Access Compliance Report

Public Rights-of-Way

(Curb Ramps)

Intersection ID: 8113	Main Street: ORR_RD	Cross Street: GRIER_RD	Location: SE
ADA ID: 8009F18BDA0F	Ramp Type: Perp	Initial Pass/Fail: Fail	Overall Compliance: No
Codes/Mitigation Info/Possible Solution		Field Measurements/Component Compliance	
Severity Score: 21.25

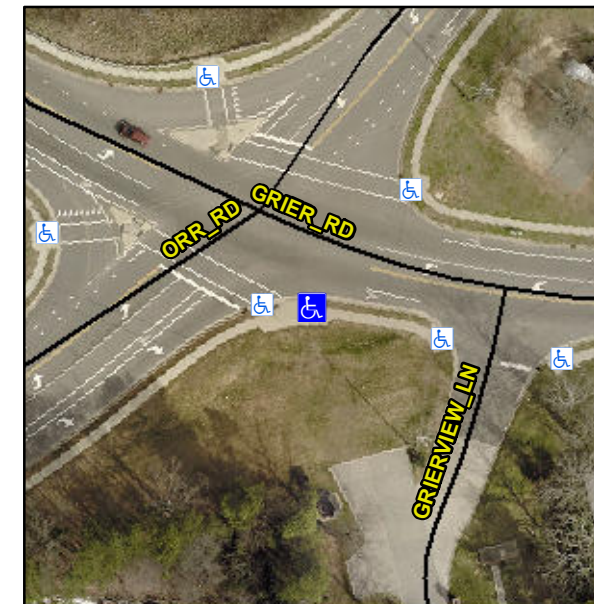
R304.5.1, R304.2.2

Compliance	Description	Data	Compliance	Description	Data
N/A	Ramp Length (in)	47.0	No	Ramp Slope (%)	9.2
No	Ramp Width (in)	47.0	Yes	Ramp XSlope (%)	2.0
N/A	Flare Type LT	N/A	N/A	Flare Type RT	N/A
N/A	Flare Slope LT (%)	N/A	N/A	Flare Slope RT (%)	N/A
N/A	Flare Traversable LT?	N/A	N/A	Flare Traversable RT?	N/A
N/A	Landing Length (in)	N/A	N/A	DWS Provided?	N/A
N/A	Landing Width (in)	N/A	N/A	DWS Contrast?	N/A
N/A	Landing Slope (%)	N/A	N/A	DWS Length (in)	N/A
N/A	Landing X Slope (%)	N/A	N/A	DWS Full Width?	N/A
N/A	Landing Curb? (Y/N)	N/A	N/A	DWS Offset (in)	N/A
N/A	Shared Landing?	N/A			
N/A	Gutter Ponding?	N/A	N/A	Gutter Slope (%)	N/A
N/A	Gutter Lip Ht (in)	N/A	N/A	Gutter X Slope (%)	N/A
N/A	Painted X Walk1?	No	N/A	Painted X Walk2?	N/A
	X Walk 1 Direction	To NE		X Walk 2 Direction	N/A
N/A	X Walk 1 Width (in)	N/A	N/A	X Walk 2 Width (in)	N/A
	X Walk 1 Slope (%)	3.1		X Walk 2 Slope (%)	N/A
	X Walk 1 X Slope (%)	0.2		X Walk 2 X Slope (%)	N/A

Remove & Replace Entire Ramp.
